# CHANGE NOTICE

**Effective Date:** OCTOBER, 2009  
**Log Number:** CN-09-415  
**Part Description:** CAM TIMER  
**Model Affected:** ALL LOW TEMP MACHINES

## **SANITIZER CAM**

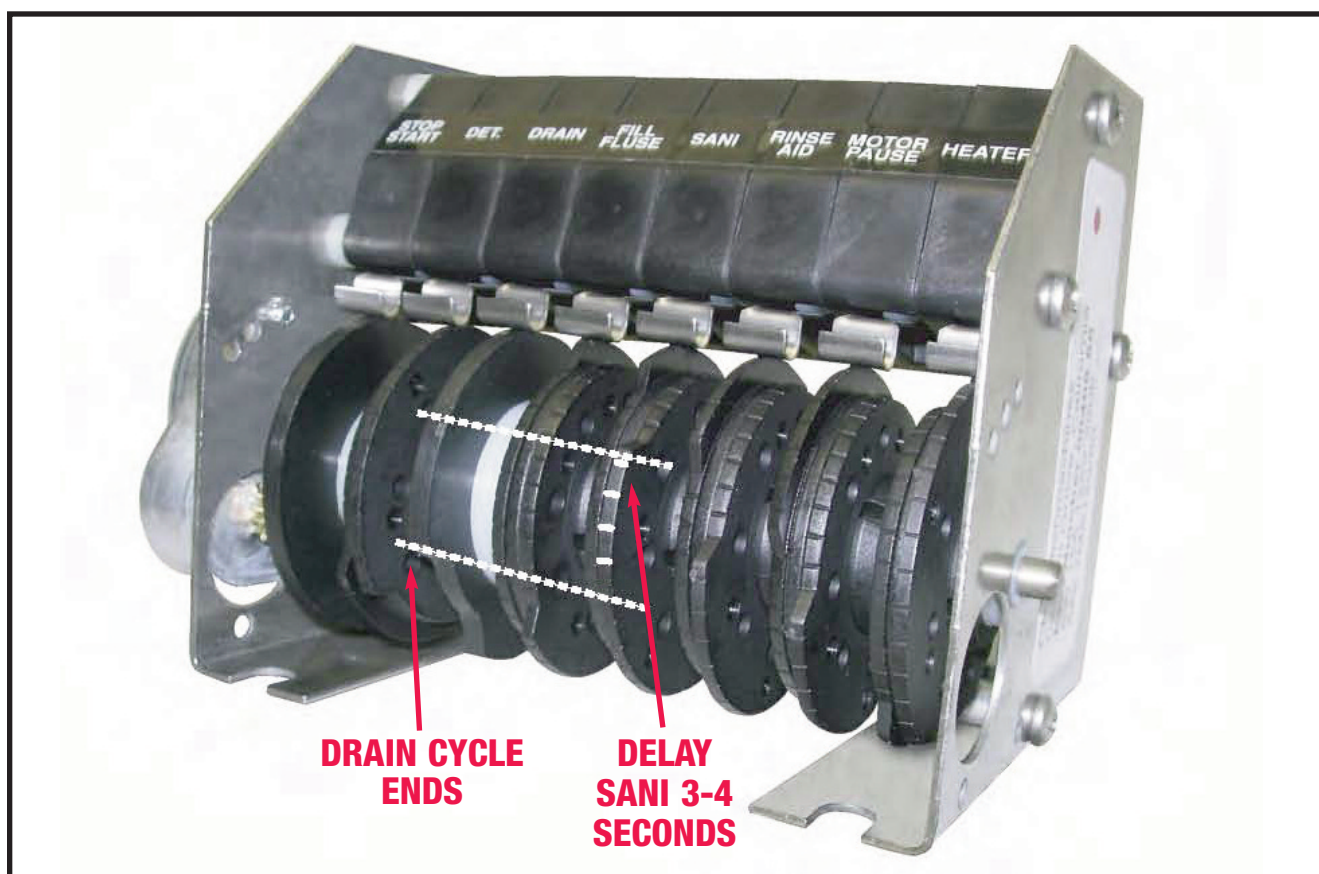
The Sanitizer Cam has been secured (glued) in position to prevent the sanitizer from being injected too early into rinse cycle. The 3-4 second delay will assure water has entered the tank preventing sanitizer from coming in direct contact with wash tank.
